Product information - BMW brake pads | HELLA

BMW brake pads

8DB 355 009-271 / 8DB 355 015-391

New allocation of the brake pads

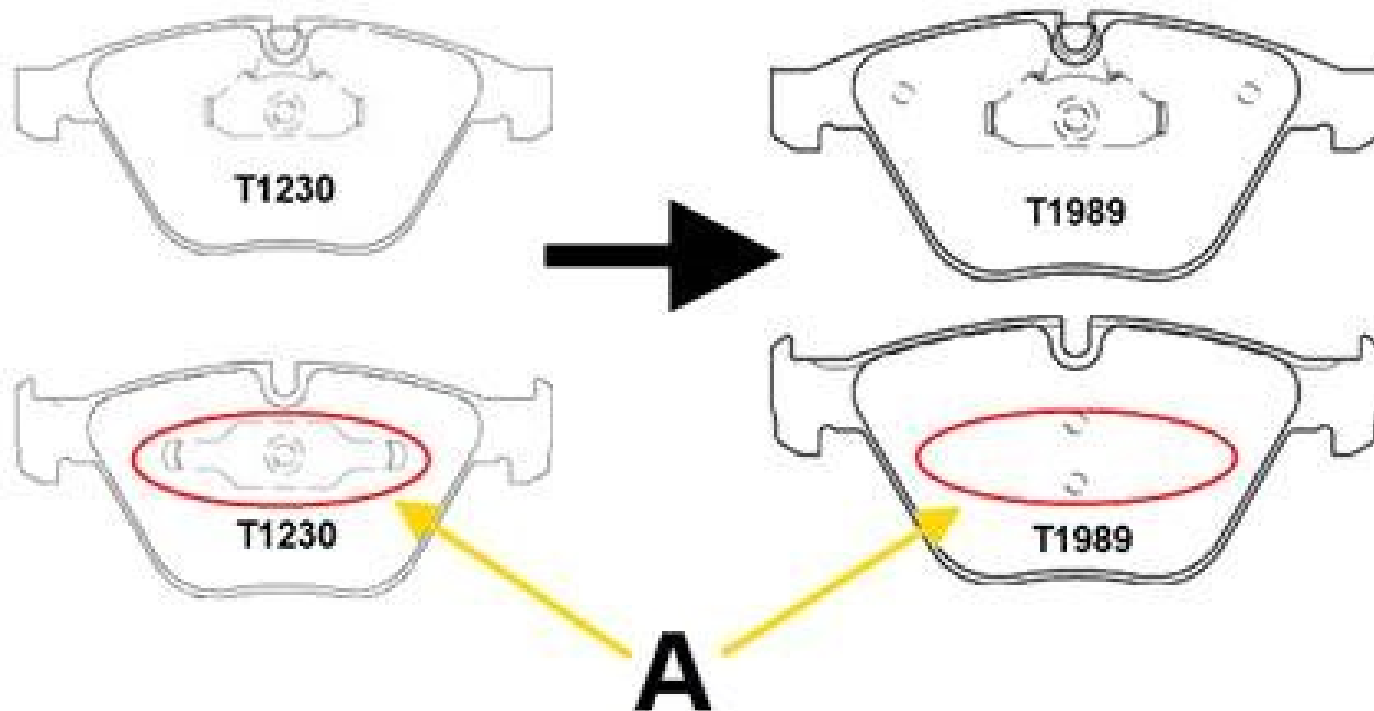
Due to a change in the serial equipment carried out by the vehicle manufacturer BMW, the following article allocation has been adapted as described in the following.

Brake pads 8DB 355 009-271 / T1230 shall still be used for the M models of the 1 series (E82) and 3 series (E90-91).

All other models are now covered by 8DB 355 015-391 / T1989. 8DB 355 015-391 / T1989 can also be retroactively used for all vehicles linked.

The difference between both brake pads is the missing retaining spring (A) on the brake pad 8DB 355 015-391 / T1989 on the fist side.
